Summary of suggested Bicycle-Related changes to draft ZO

Final revision date: 1-21-2010

The following summary of concepts frames all of the suggested modifications to the 9-15-09 draft Zoning Ordinance:

Ground mount (non-vertical) rack & spacing

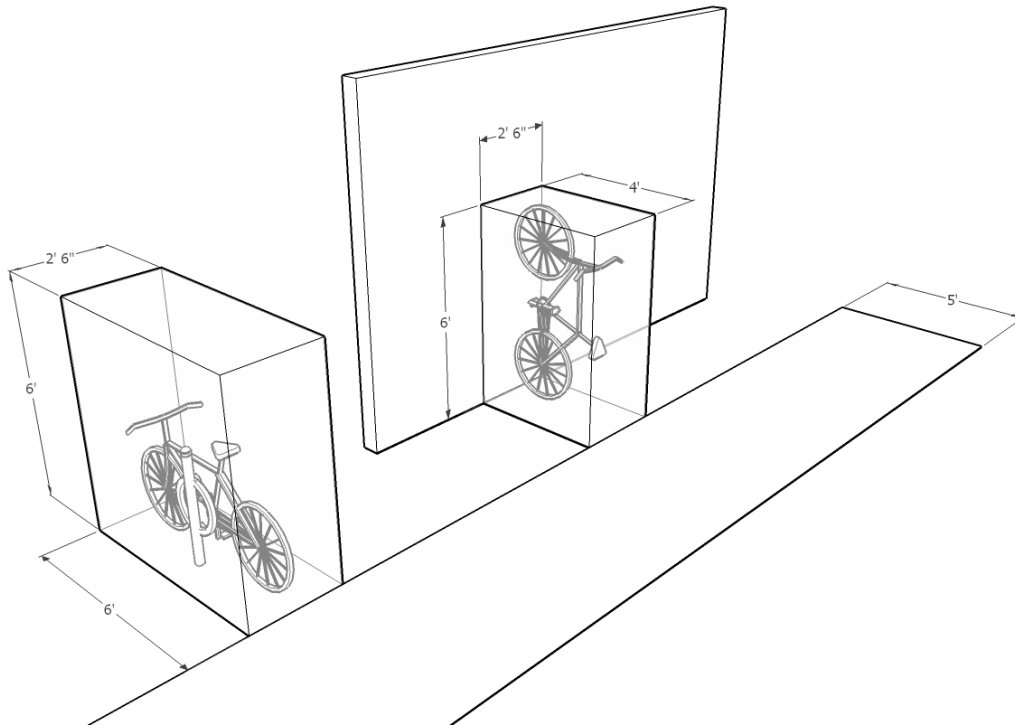
- Support a wheel and frame in the center of the bicycle parking stall (no overlap), keeps wheel and frame in a single plane and prevents rotation of the bicycle when placed in the rack,

- Separate rack designs to apply to short term and long term parking,
- Who approved the rack?
 - Ordinance defines rack, Zoning Administrator approves, with consideration/guidance from TE. (allows for creativity).

- Approval of racks should include # of bike parking spaces the specific rack is designed to accommodate from manufacturer.
- Need 6’ vertical clearance requirement,

- Does 3% slope work to provide stable surface for rack mounting?
- Surfacing: must be paved with materials approved by asphaltic or concrete surface approved by DPW, and may use pervious paving (no gravel, landscape stone, woodchips,)

- Provide examples of acceptable racks in supporting document,
- Accommodate U-lock (including removal of front wheel and locking it to the rear fork and frame) and cable lock,

- Eliminate 2.5’ width if information from rack manufacturers reflects rack side is not modular standard or being manufactured (keep current 2’ width).
